V2500-A1/A5 SERIES PROPULSION SYSTEMS SERVICE BULLETIN

This document transmits the Revision 2 of Service Bulletin V2500-ENG-72-0329.

V2500-ENG-72-0329

ENGINE – ATTACHING PARTS AND FITTINGS – HP SYSTEM – INTRODUCTION OF REVISED BRACKETS
TO PROVIDE INCREASED CLEARANCE WITH FUEL MANIFOLDS

Removal of the brackets
Figure 1

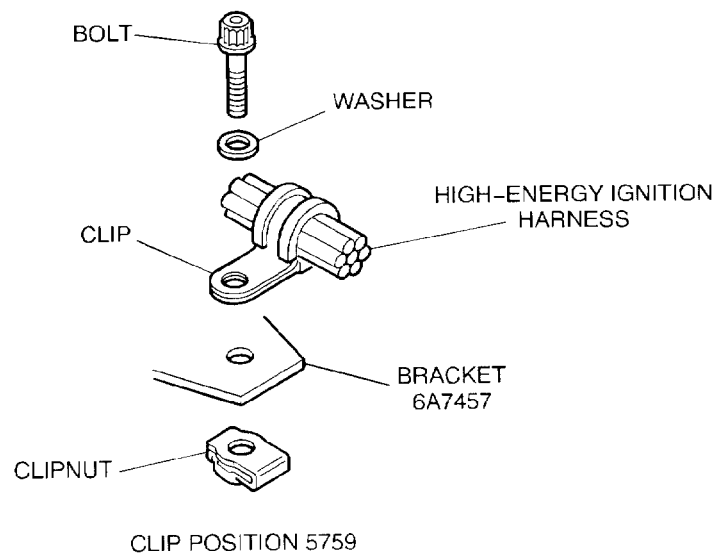
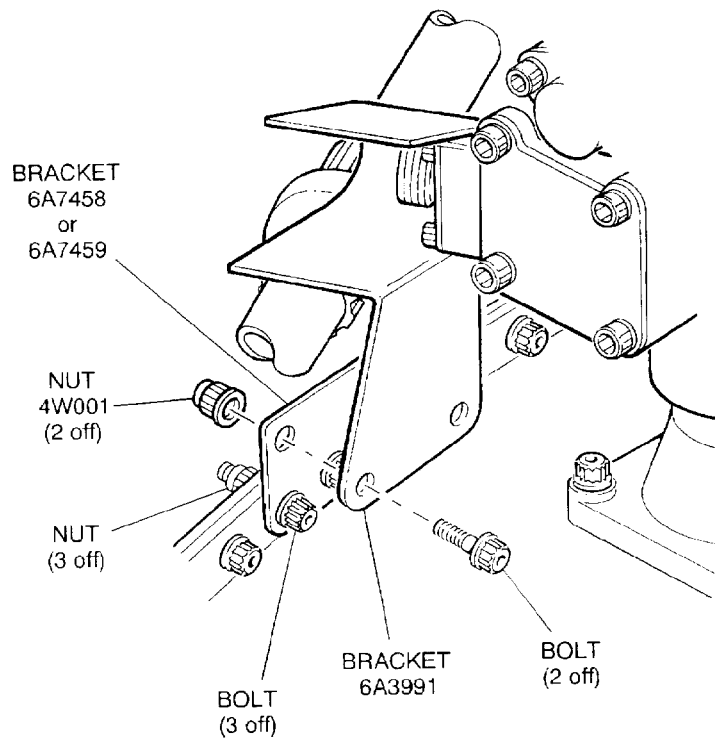
- (1) Remove Brackets 5W8363 and 6A5911 or 6A3992 from the HPC/Diffuser flange. (Refer to Figure 1).
 - (a) Disconnect the clip position CP5759 of the high-energy ignition harness, from the bracket 5W8363.
 - (i) Remove the bolt washer and clip-nut.
 - (ii) Move the harness clear of the bracket.
 - (b) Remove the bracket 5W8363 from the HPC/Diffuser case flange.
 - (i) Remove the three nuts and bolts that attach the bracket to the flange.
 - (c) Remove the air deflector bracket 6A3991 from bracket 6A5911 or 6A3992.
 - (i) Remove the two bolts and clip nuts that attach bracket 6A3991 to bracket 6A5911 or 6A3992. Discard the clip nuts.
 - (d) Remove bracket 6A5911 or 6A3992 from the HPC/Diffuser case flange.
 - (i) Remove the three nuts and bolts that attach the bracket to the flange.

Installation of the brackets
Figure 2

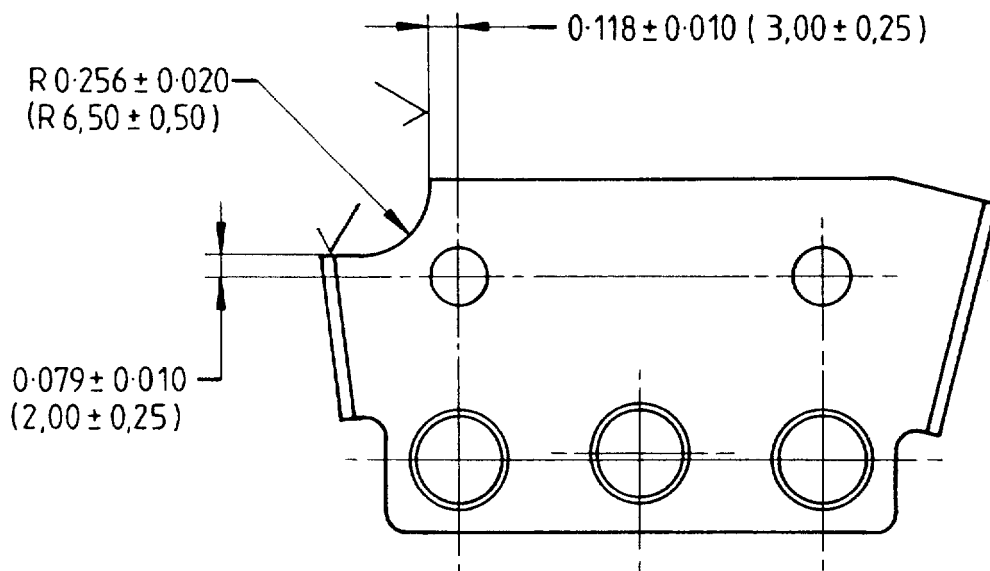
- (2) Rework the brackets 6A3992 (Refer to 3.A.(3)), 6A5911 and 5W8363 (Refer to 3.A.(4)).
- (3) Install the re-worked brackets 6A7458 or 6A7459 and 6A7457 to the HPC/Diffuser case flange. (Refer to Figure 1).

- (a) With the three nuts and bolts, attach bracket 6A7458 or 6A7459 to the flange
 - (i) Torque load the nuts to between 180 to 220 lbf/in. (20,34 to 24,86 Nm).

- (b) With the two new nuts 4W001 and two bolts, attach the air deflector bracket 6A3991, to bracket 6A7458 or 6A7459.
 - (i) Torque load the nuts to between 36 and 45 lbfin. (4 and 5 Nm).

- (c) With the two nuts and bolts, attach bracket 6A7457 to the flange.
 - (i) Torque load the nuts to between 180 and 220 lbfin. (20,34 and 24,86 Nm).

- (d) With the nut washer and bolt attach clip position CP5759 of the high-energy ignition harness to bracket 6A7457.
 - (i) Torque load the bolt to between 36 and 45 lbfin. (4 and 5 Nm).

Rework bracket 6A5911
Figure 3

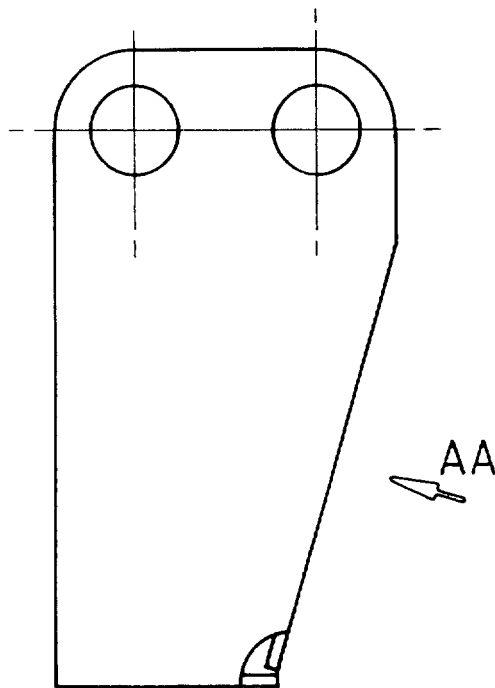
(b) Attaching bracket 6A5911 has been revised, a corner has been removed.

VIEW SHOWING REWORK OF 6A5911

MATERIAL REMOVAL WHERE SHOWN THUS ✓

SURFACE FINISH TO BE 125 MICROINCHES (3,2 MICROMETRES)

BREAK SHARP EDGES 0.012 ± 0.008 (0,30 ± 0,20)

| (d) Rework the brackets in the area(s) shown | Use standard workshop equipment.

| (h) Visually examine and measure the dimensions of the reworked area(s) | Refer to Figures 3 and 4. |

Rework bracket 5W8363
Figure 4

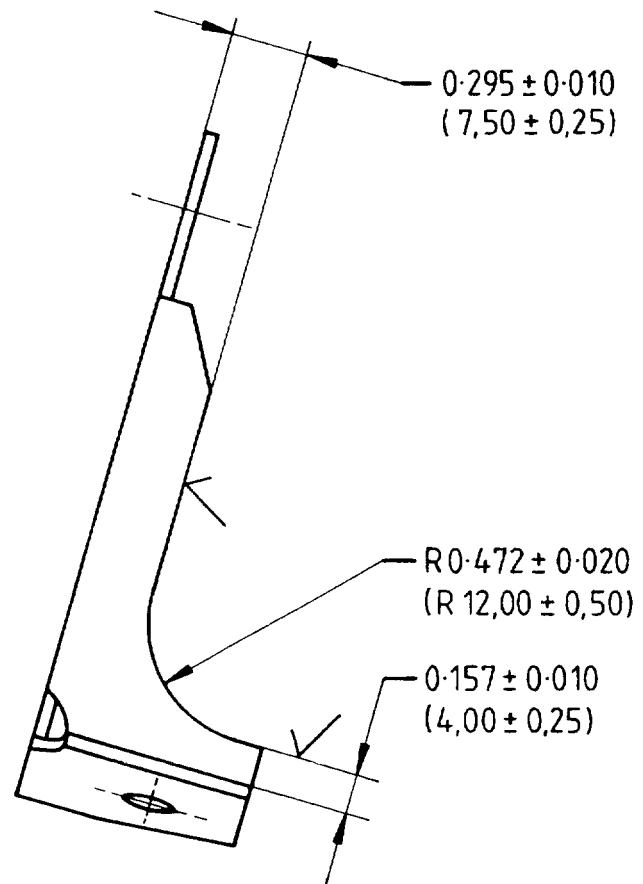
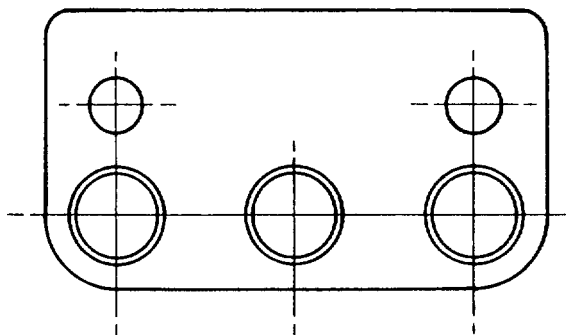
(a) Clipping bracket 5W8363 has been revised, the profile of the folded edge has been relieved.

MAIN VIEW OF BRACKET
5W8363

VIEW ON  AA
SHOWING REWORK OF BRACKET

Bracket 6A3992 – Before and after alteration
Figure 5

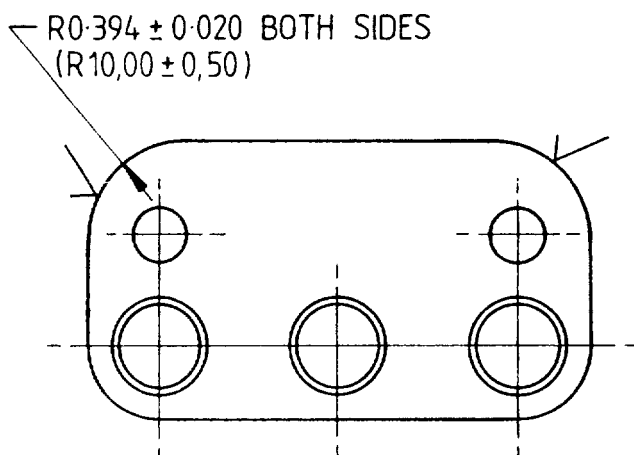
(i) A rework standard of attaching bracket 6A3992 is introduced with an increase in size of the top corner radii.

MAIN VIEW OF BRACKET 6A3992
BEFORE ALTERATION.

VIEW OF BRACKET
AFTER ALTERATION.

PROCEDURE	RELATED DATA
(a) Chemically clean the bracket	Use chemical cleaning equipment. Refer to the Standard Practices Manual (SPM), TASK 70-11-03-300-503.
(b) Apply marking ink to the area(s) to be reworked	Use standard workshop equipment. Refer to Figure 5.
(c) Mark-off the area(s) of the bracket to be removed	Use standard workshop equipment. Refer to Figure 5.
(d) Rework the bracket in the area(s) shown	Use standard workshop equipment. Refer to Figure 5.
(e) Remove any sharp edges	Use standard workshop equipment. Refer to Figure 5.
(f) Chemically clean the bracket	Use chemical cleaning equipment. Refer to the Standard Practices Manual (SPM), TASK 70-11-03-300-503.

- (h) Visually examine and measure the dimensions of the reworked area(s)
- Refer to Figure 5.
